## **Addendum Number One**

**Date of Issue:** 02/22/13

**Project:** USC Preston College Bathroom and Flooring Renovations  
Project Number: H27-6086-SG

**AD101**

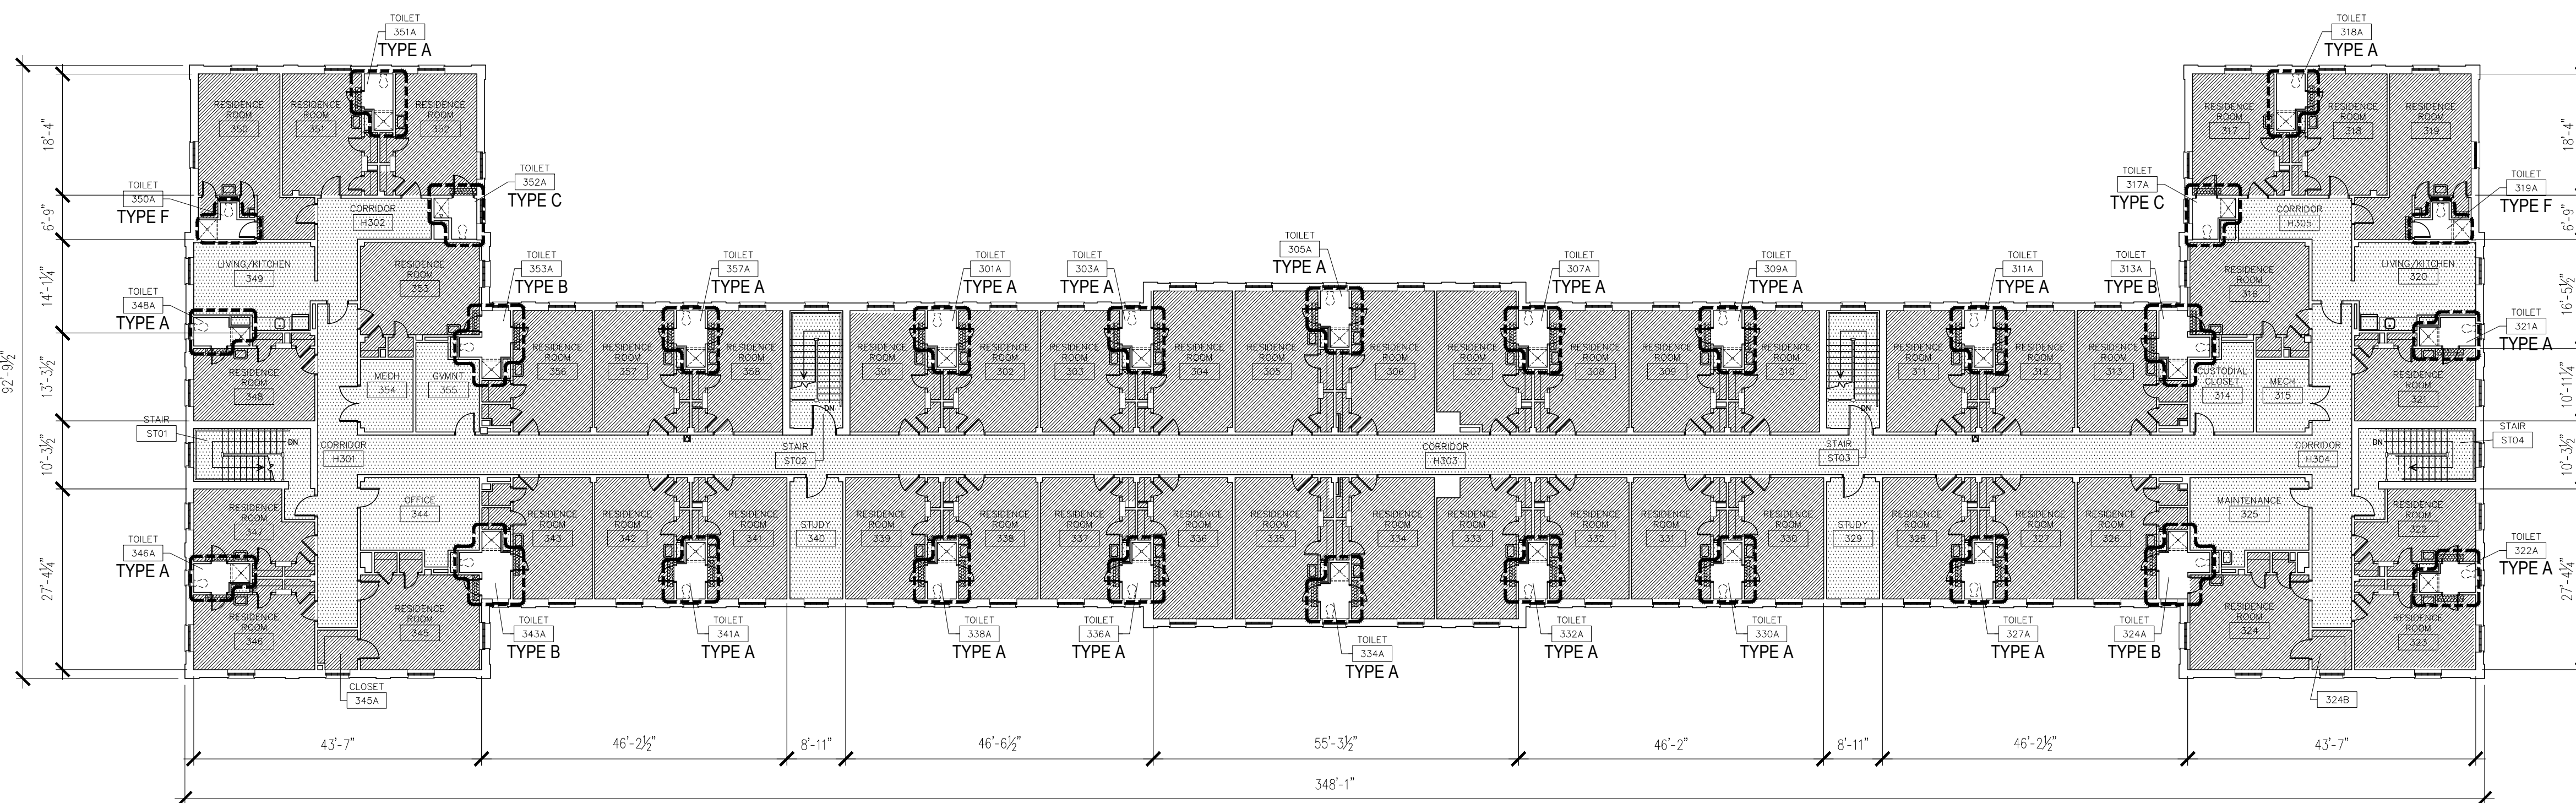
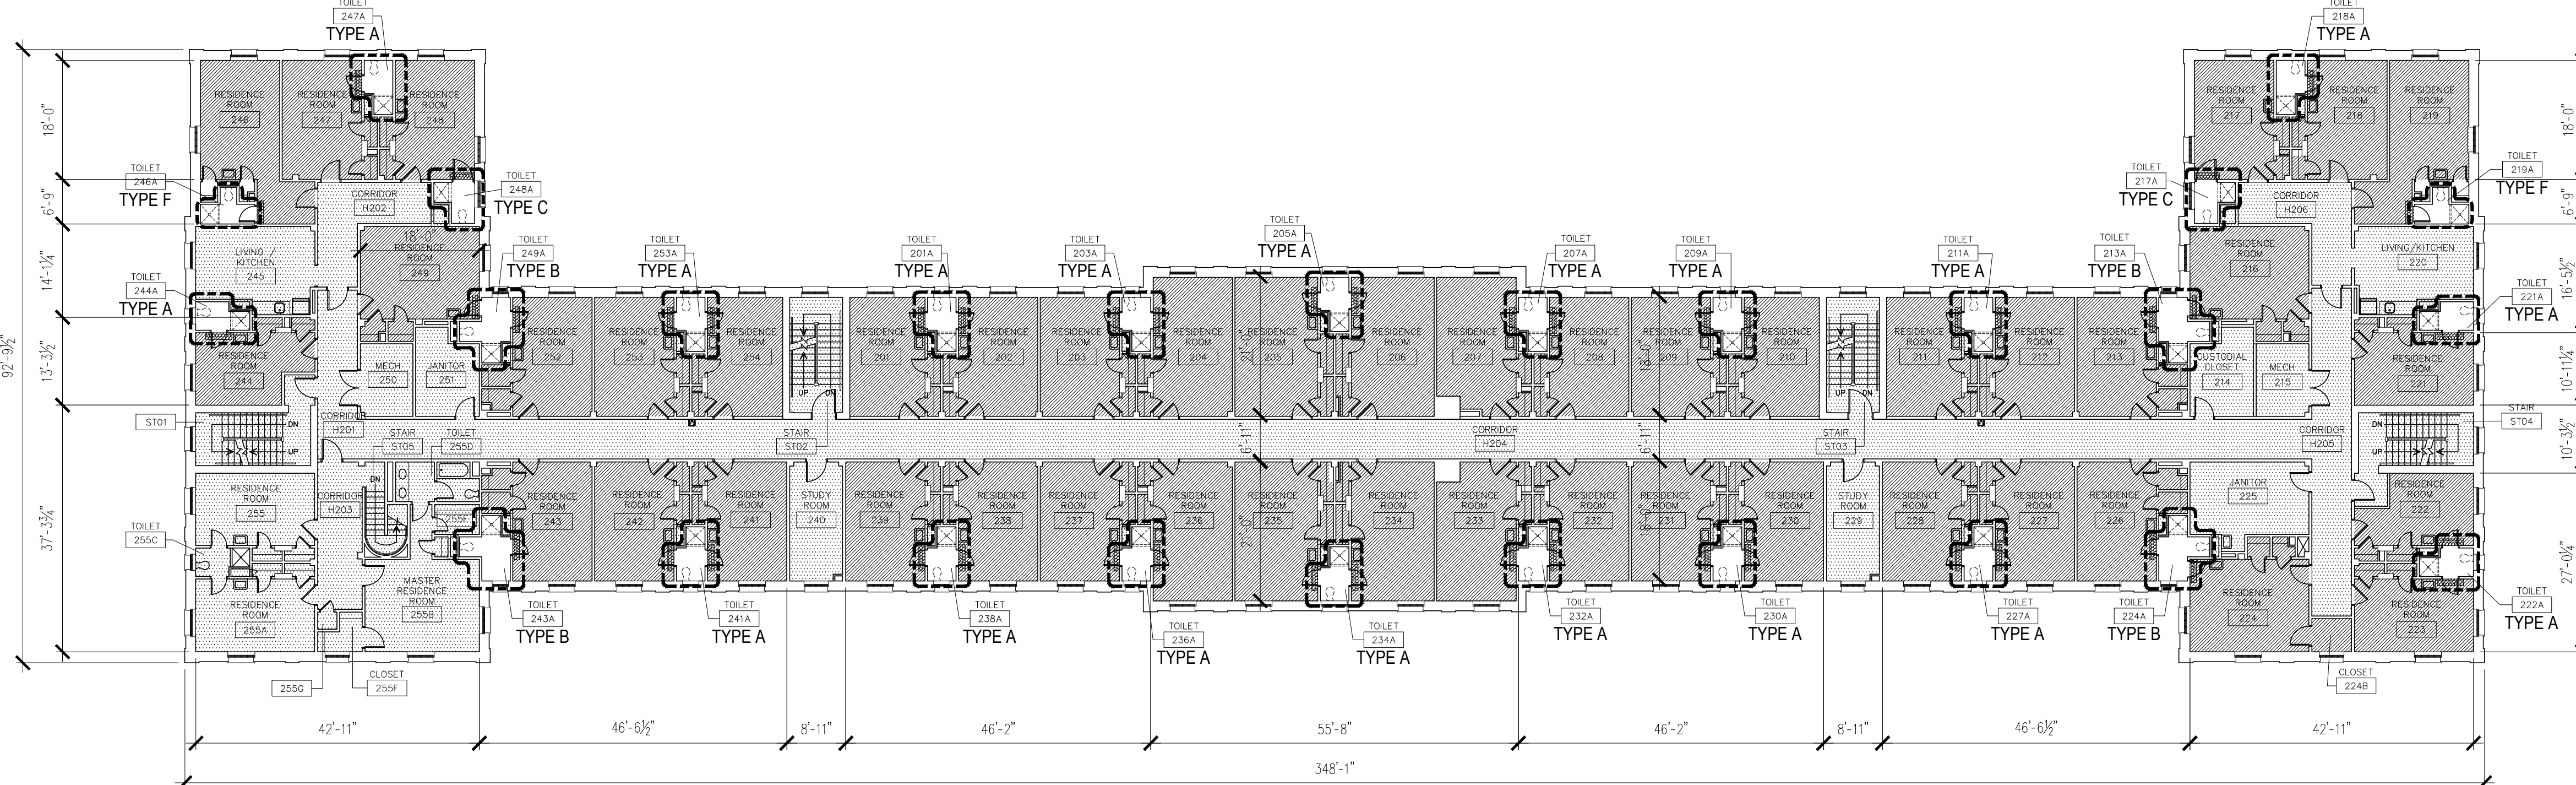
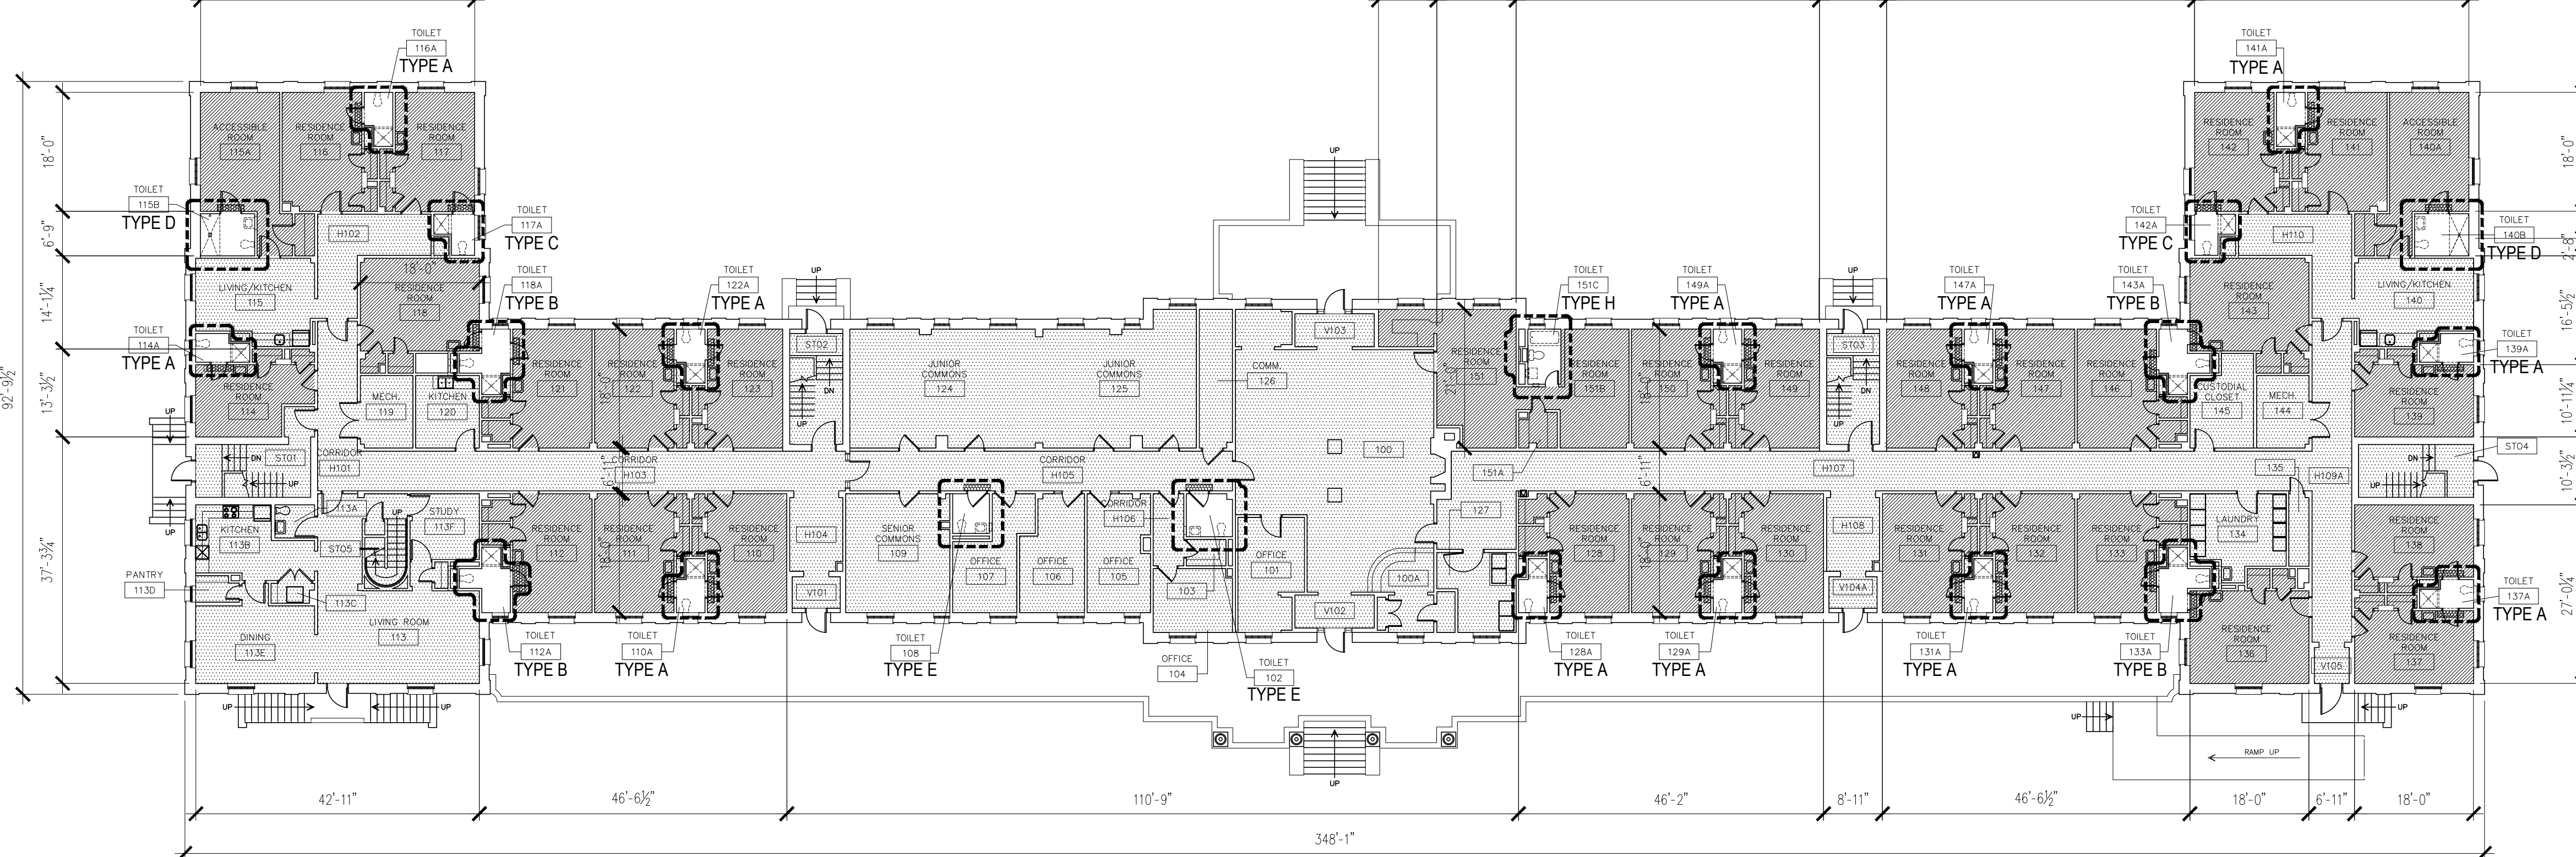
7. **SHEET AD101** Remove and replace with enclosed sheet AD101.
8. **SHEET AD111 / B2** Delete keyed notes 8 and 13 between toilet and lavatory.
9. **SHEETS AD111, A111 and A131 / A1 Room Listing** Delete room numbers  
255C and 216A. Add 218A to Opposite Hand Room Listing.
